Comhairle Contae Chorcaí
Cork County Council

26th June 2009

**Re: D0295-01 - Schull Waste Water Discharge Licence Application –
Reply to Notice in accordance with Regulation 18(3)(b) of the Waste
Water Discharge (Authorisation) Regulations 2007**

Drawing Title: ATTACHMENT B.2
SITE LAYOUT BOUNDARY
PROPOSED WASTEWATER
TREATMENT PLANT
(DRAWING 1 OF 2)

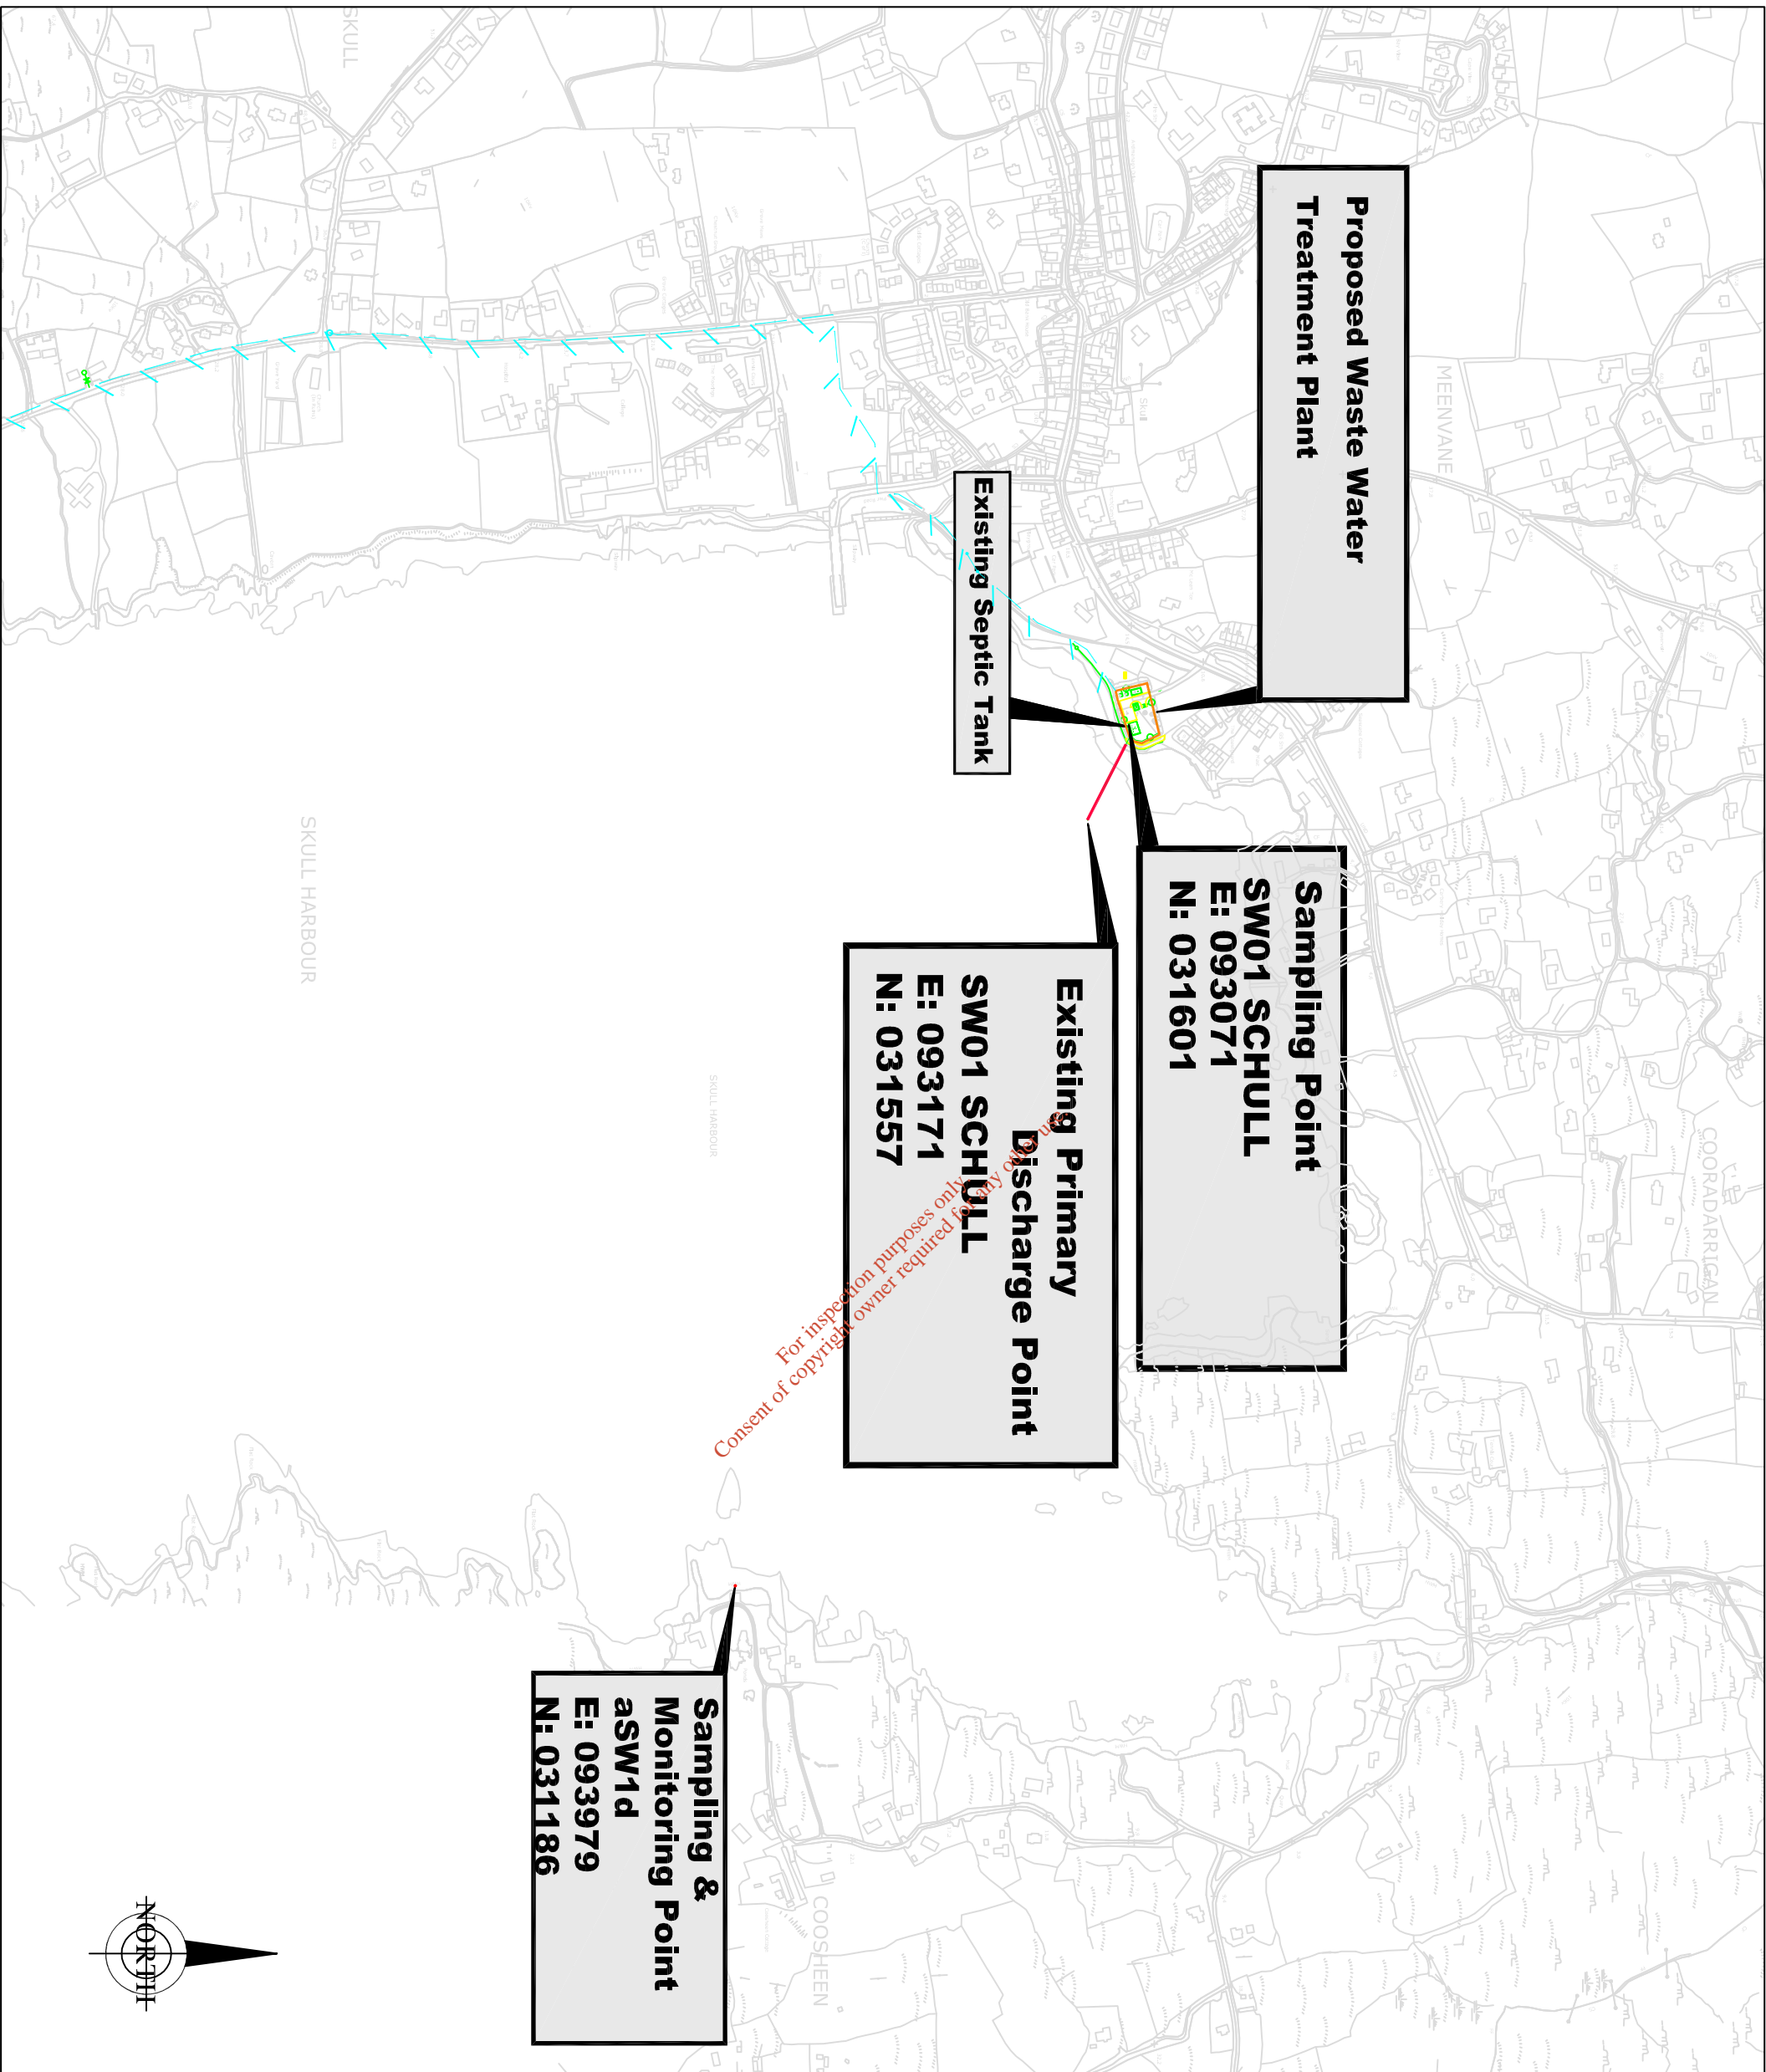
- ii. Section B attachments have been amended in relation to sampling and discharge points and are attached as part of this submission.

- (a) B2.03 Proposed WWTP Rev B
- (b) B3.01 Primary Discharge Point Rev B
- (c) B4.01 Secondary Discharge Point Rev B

The emissions from the WWTP can be monitored through the sampling point SW01 Schull (see Map Schull B2-03 for location).
